Item 6.**Development Application: Sites 7 and 17, 960A Bourke Street, Zetland – D/2017/564****File No.:** D/2017/564**Summary**

Date of Submission:	The application was lodged on 5 May 2017. Several amendments including significant design changes have been submitted since lodgement. The most recent amendments were submitted on 24 April 2019.
Applicant:	Mirvac and Landcom
Architect/Designer:	Tzannes (original submission Silvester Fuller)
Developer:	Mirvac and Landcom
Owner:	Landcom
Cost of Works:	\$125,721,654 (original submission \$98,514,463)
Zoning:	B4 - Mixed Use zone - Permissible With Consent
Proposal Summary:	<p>Consent is sought for a new mixed-use development on Site 7 and Site 17 in the Green Square Town Centre (GSTC) comprising the following:</p> <ul style="list-style-type: none">• Site 7 includes a new 16 storey building plus roof plant with 123 residential apartments on Levels 6 - 18, retail uses on Level 1, commercial uses on Levels 4 and 5, and an entertainment facility (cinema) across Levels 1-5. A landscaped podium roof terrace is on Level 6.• Site 17 includes a new 13 storey building plus roof plant with 71 residential apartments on Levels 2-13, retail uses on Leve

Figure 15: LEP height departure (shown in red) - envelope view from Plaza

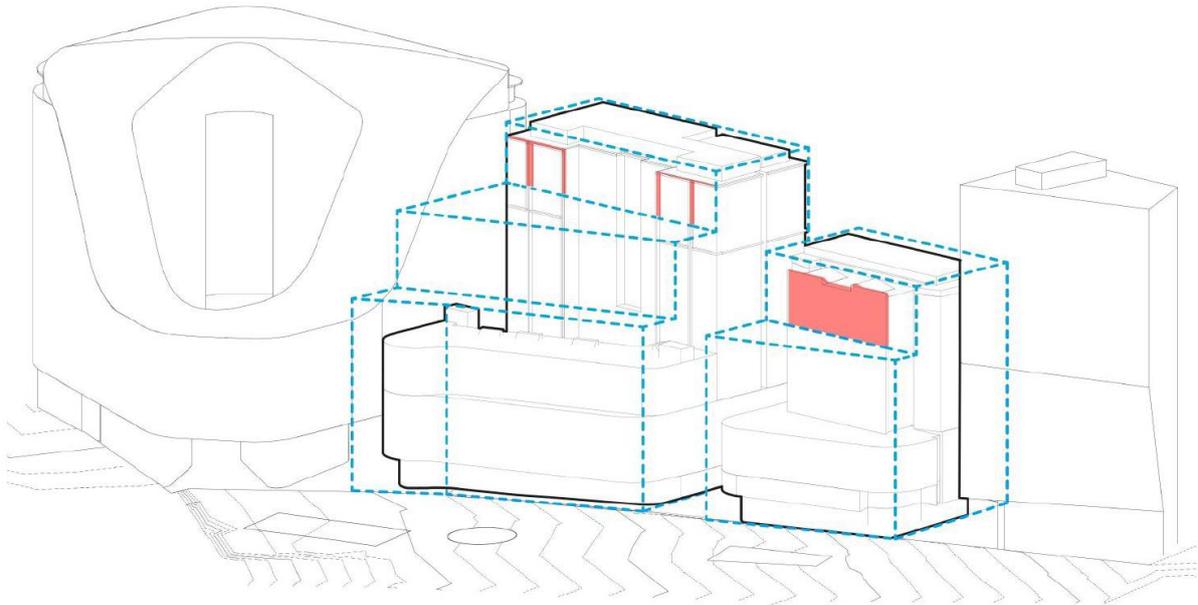
40. For Site 17, a strip, measuring a maximum depth of 1.5m across Levels 11-13 of the south western facade (facing the Plaza) of the residential tower protrudes laterally beyond the RL 50 LEP height control portion (equivalent to a height of approximately 33m). At this location the proposed building height is approximately 43m, which equates to a variance of 20.92%.
41. For Site 7, a portion of the south western facade (facing the Plaza) on Levels 17 to 19 of the residential tower protrudes laterally 450mm into the RL 64 height limit. The protrusion is attributed to facade articulation. For this portion, the building has a height of 72.4m, a variation of 8.4m (13%).
42. The departures from the height controls are illustrated in the Figures below.

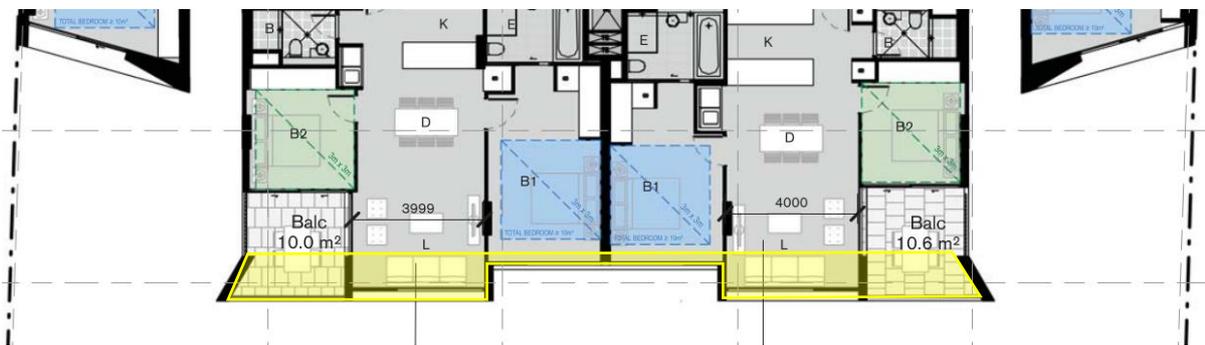
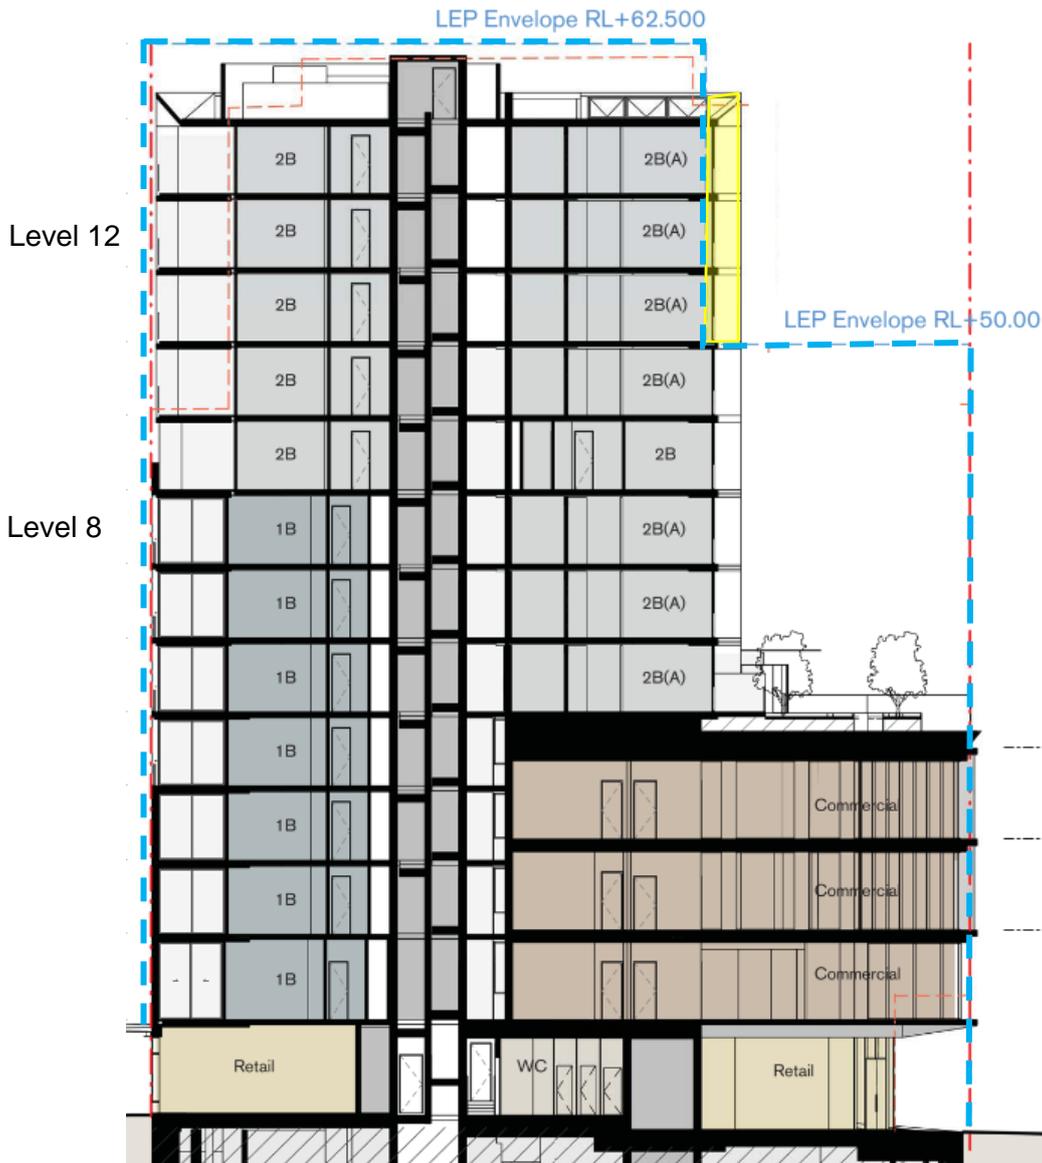
On Site 17, a portion of the tower on the south western (Plaza) elevation of the tower protrudes into the maximum permissible height (RL50) by 10.46m resulting in a 20.9% variation (to a depth of 1450mm at Levels 11 to 13). As discussed in this report, the Height of Buildings variation request is supported given that the non-compliances are minor lateral protrusions.

Figure 17: Section of Site 7 showing SLEP (GSTC) 2013 maximum height control with the portion of the building articulation that exceeds LEP RL 64 highlighted in yellow

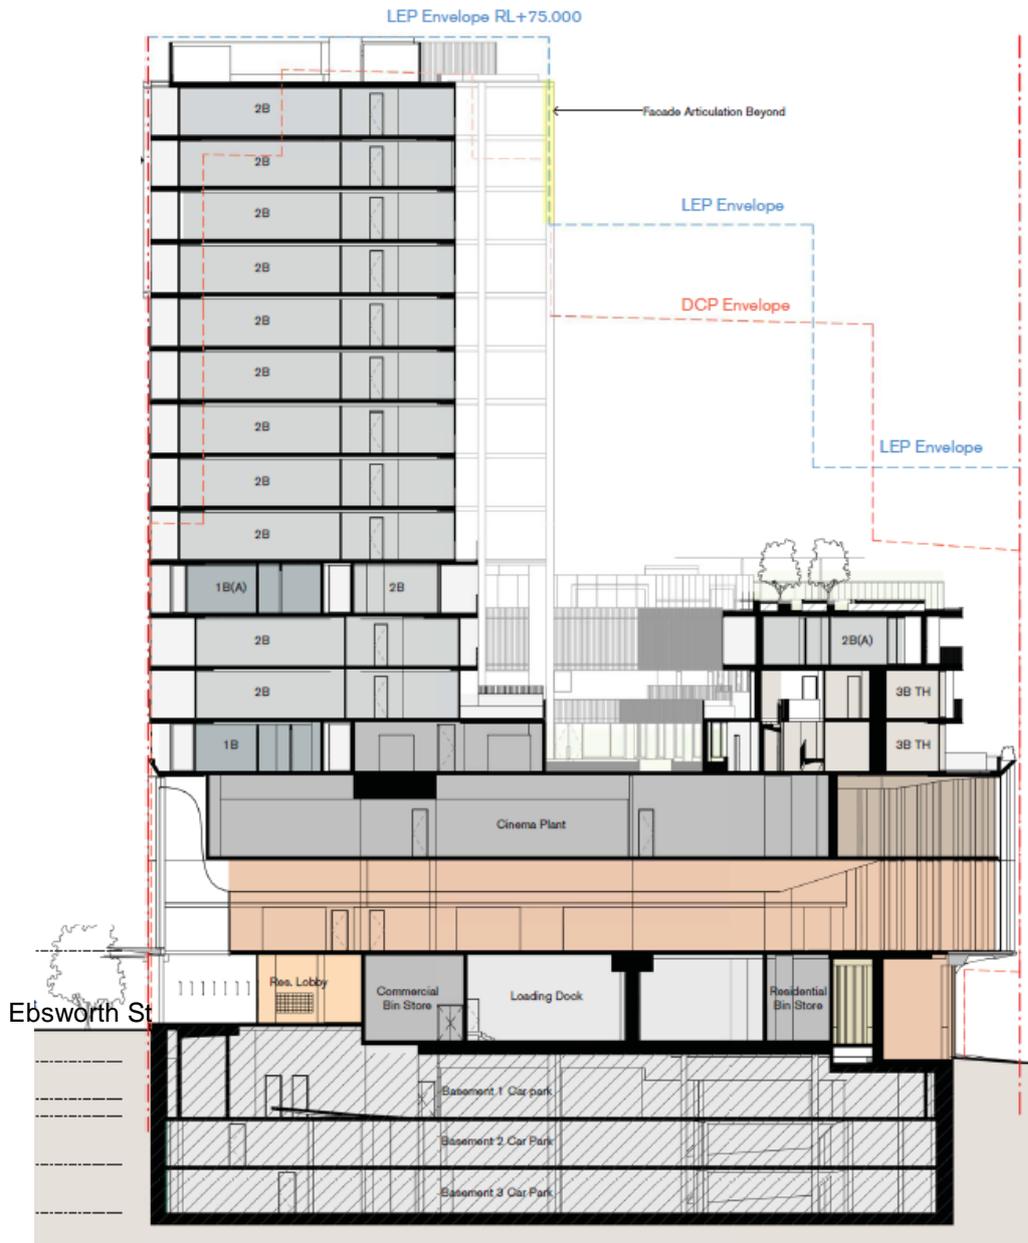
On Site 7, elements of the facade articulation on the south western (Plaza) elevation of the tower protrudes into the maximum permissible height (RL64) by 8.4m resulting in a 13% variation (to a depth of 450mm at Levels 17 to 19).

Figure 18: Shadow diagram at 12 noon, midwinter. Additional shadows from the proposal are shown in red, with the DCP required 4m strip shown by the dashed purple line and the DCP required "consolidated area" shown by the dashed green line.

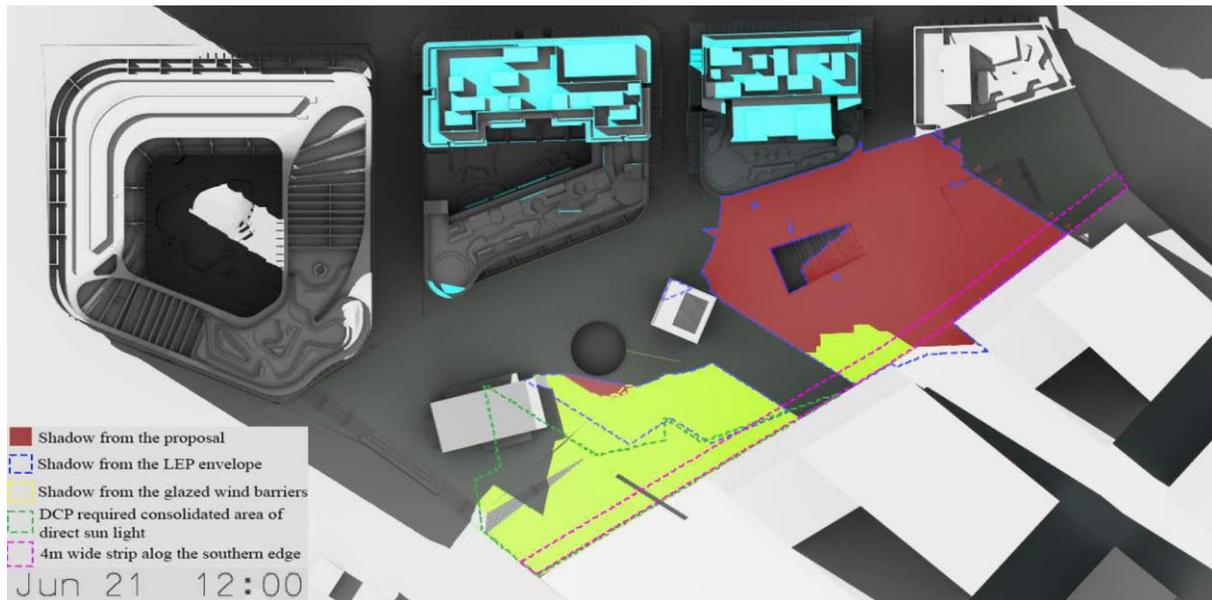
55. The applicant was asked to demonstrate the impact of the non-compliance in terms of overshadowing to the Green Square Plaza. More specifically, the DCP requires the following:
- At least 50% of a 4m wide strip along the full length of the southern edge of the Green Square plaza between 12pm and 2pm at midwinter to achieve direct sunlight during these times.
 - Ability to achieve consolidated areas of direct sunlight between 12pm and 2pm at midwinter generally consistent with the location and size indicated in Figure 3.2 of GSTC DCP.

56. As demonstrated in the Figures above, notwithstanding the height exceedances, the proposal maintains direct sunlight between 12 midday and 2pm at midwinter generally consistent with the location and size of the consolidated areas of the Plaza, as required by the DCP.
57. In addition, solar access to at least 50% of a 4m wide strip along the southern edge of the Plaza is achieved by the proposal.

Figure 22: Section of Site 7 with additional storey highlighted in yellow. The SLEP (GSTC) 2013 maximum height is shown with a blue dashed line.

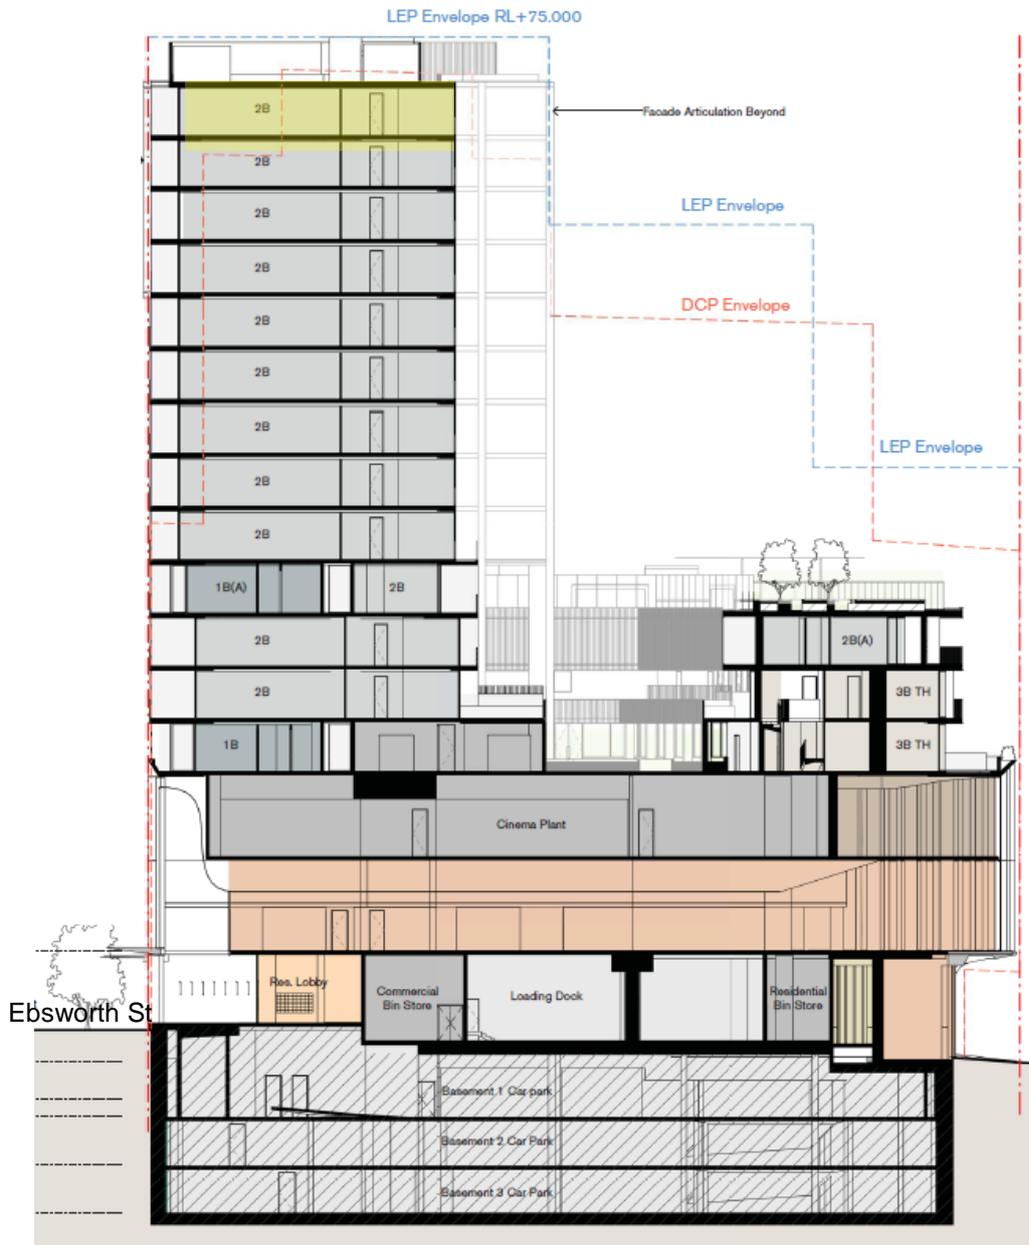
68. At 16 storeys, the building on Site 7 exceeds the DCP height in storeys control by one storey (though is within the LEP height limit).

72. On balance, as the additional storey on both Sites are within the maximum permitted LEP height and will not result in unreasonable impacts (refer earlier discussion), the proposal is considered to be acceptable.

Figure 23: Section of Site 17 showing that the additional storey is contained within the upper limit of the SLEP (GSTC) 2013 maximum height (shown with a blue dashed line) and the upper limit of the SDCP (GSTC) 2012 building envelope (shown with a red dashed line).

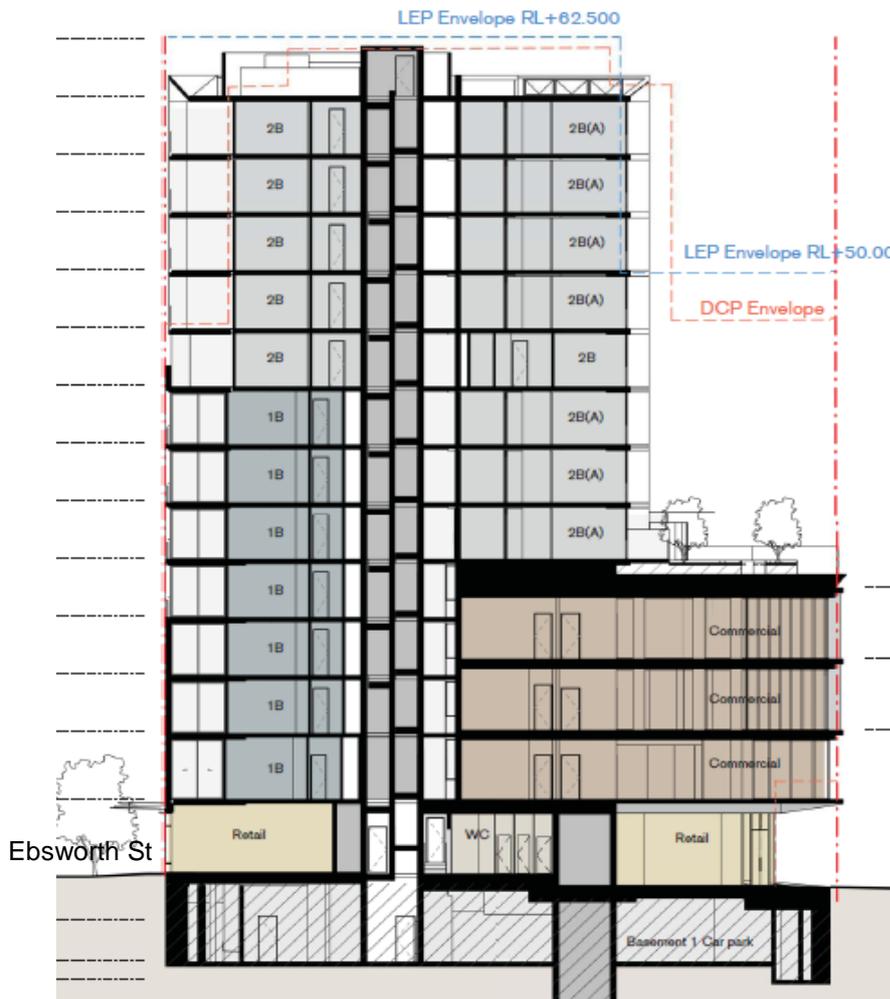
- 69. At 13 storeys, the building on Site 17 also exceeds the DCP height in storeys control by one storey (though is also within the LEP height limit and the upper limit of the DCP prescribed envelope).

Figure 25: Typical Kitchen Section

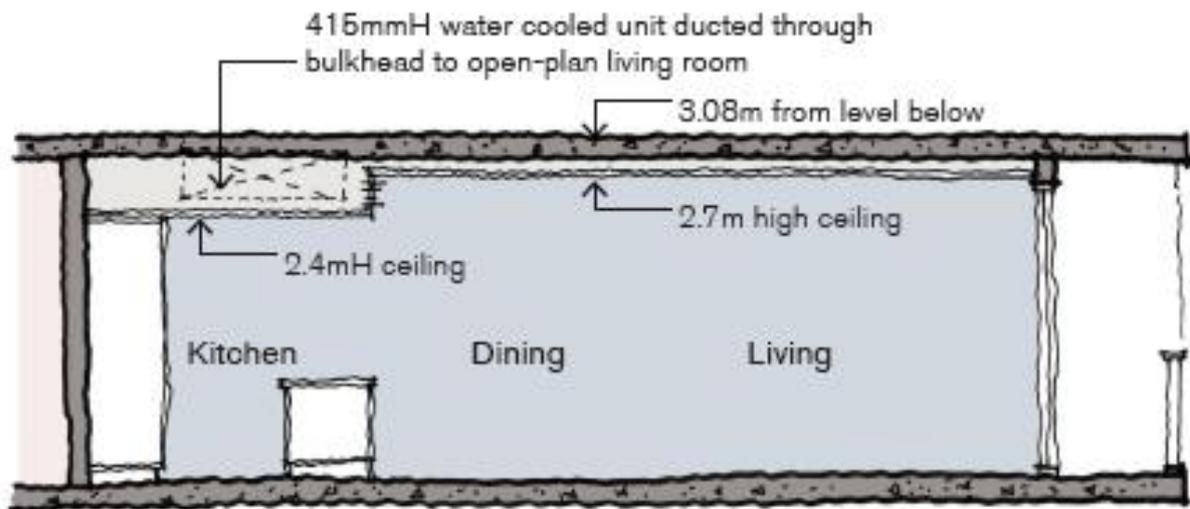
74. The ADG contains the following two standards of particular note for this development:
- 2.7m minimum ceiling height in habitable rooms; and
 - 3.3m minimum ceiling height on the ground and first floor to promote future flexibility of use.
75. For the residential apartments, a compliant ceiling height is provided to the living and sleeping areas, however a ceiling height of 2.4m is proposed to kitchens.

Figure 29: DCP Upper Level Setback - Site 7 Section with dashed red line indicating DCP envelope and the portion of the building that exceeds the DCP upper setback highlighted in yellow

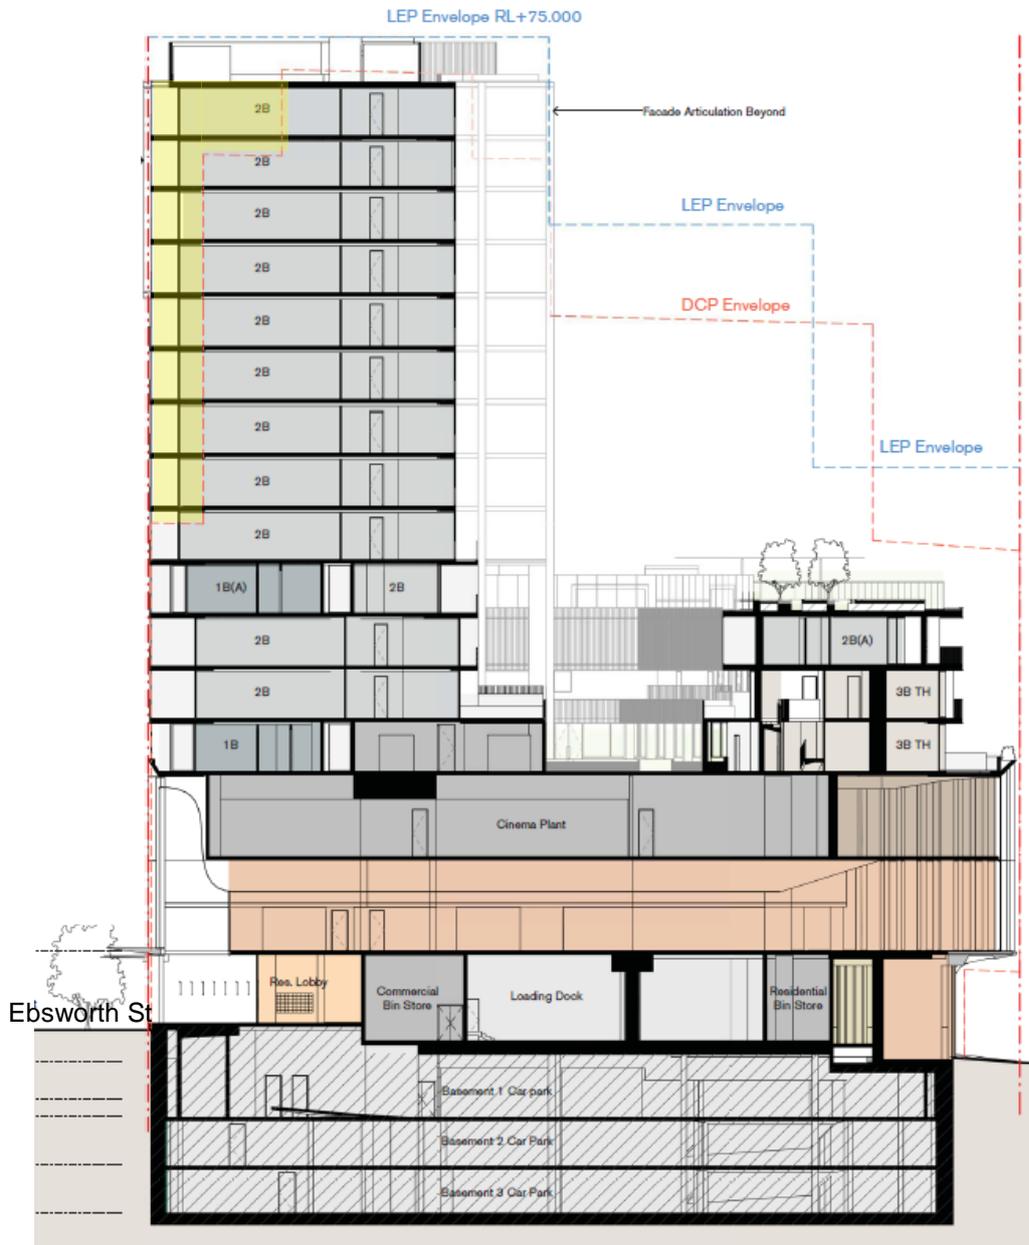
- 89. The proposed buildings, with no setbacks as it fronts Ebsworth Street, do not comply with the following controls:
 - (a) Under the ADG, the floors 9 storeys and above are required to have a 24m separation from other buildings; and
 - (b) Under the DCP, above an 8 storey street frontage height, a 3m secondary setbacks is required.

91. On balance, the proposed non-compliances are considered to be acceptable, particularly noting the following:
- (a) At between 19m and 21m, the building separation non-compliances between the proposed development on Sites 16A and 16B (which terminates at level 10) are considered to be acceptable and unlikely to result in any unreasonable impacts that would require mitigation.
 - (b) Due to the layout of the Green Square Town Centre public domain and development blocks (established as part of the LEP and DCP), the orientation of Sites 7 and 17 are such that optimum solar access to the buildings is gained from the Ebsworth Street frontage. Consequently, no setbacks have been provided to maximise the amount of sun access to the balconies and living room spaces of those Ebsworth Street facing apartments.

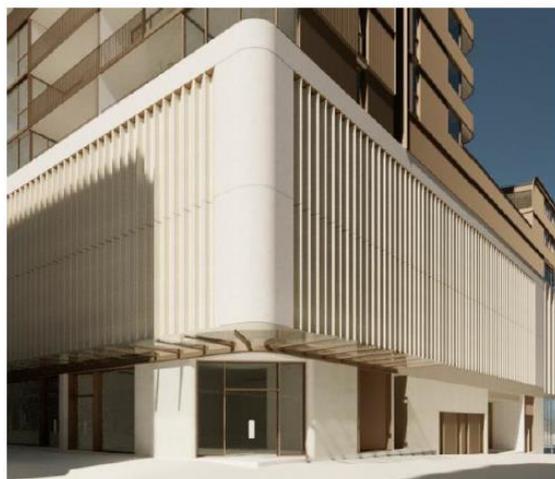
The solid framing of the white element around the blank facade of the cinema at the base of the building compromises the ambitions of the form. The scalloping of the surface on the Ebsworth Street frontage was not adequately explained in the drawings. The framing could be deleted and its verticality emphasised to give greater visual integration to the overall 3D. This is a dominant element and needs further investigation and refinement.
